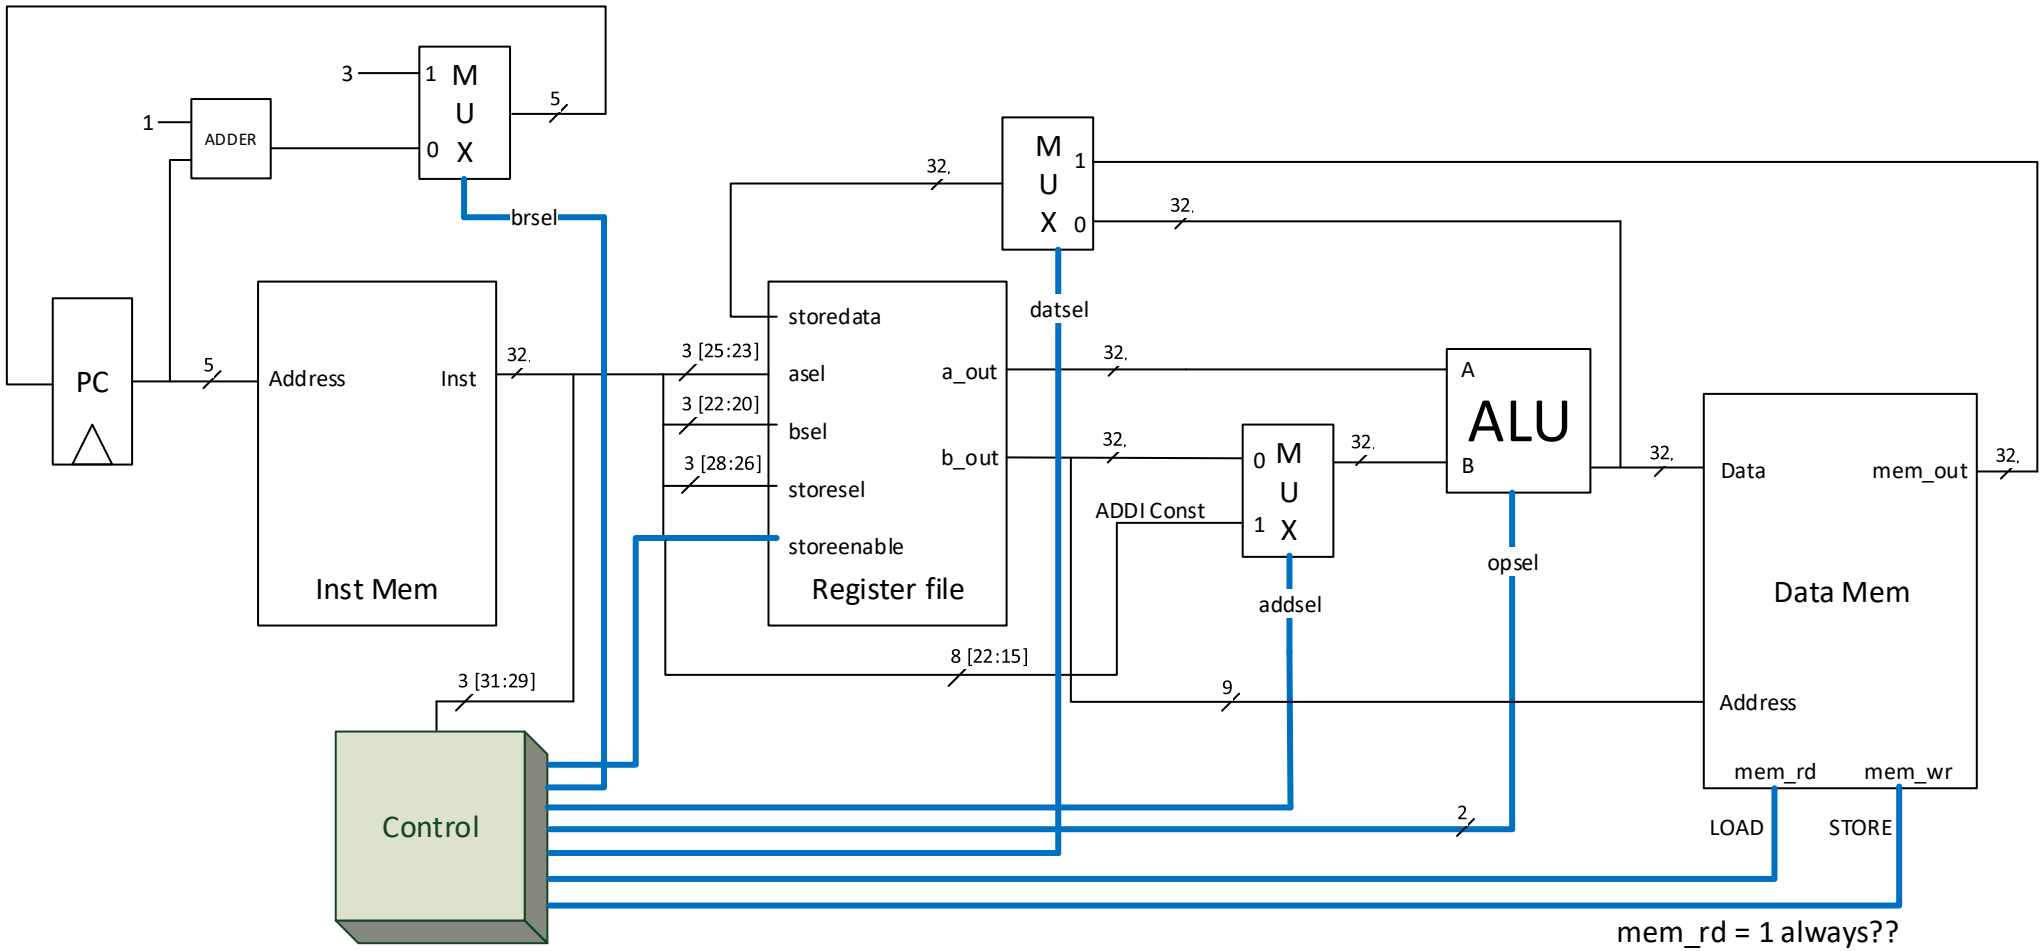
mem_rd = 1 always??
We have a mux on mem_out
so to have mem_rd = 1
always is fine
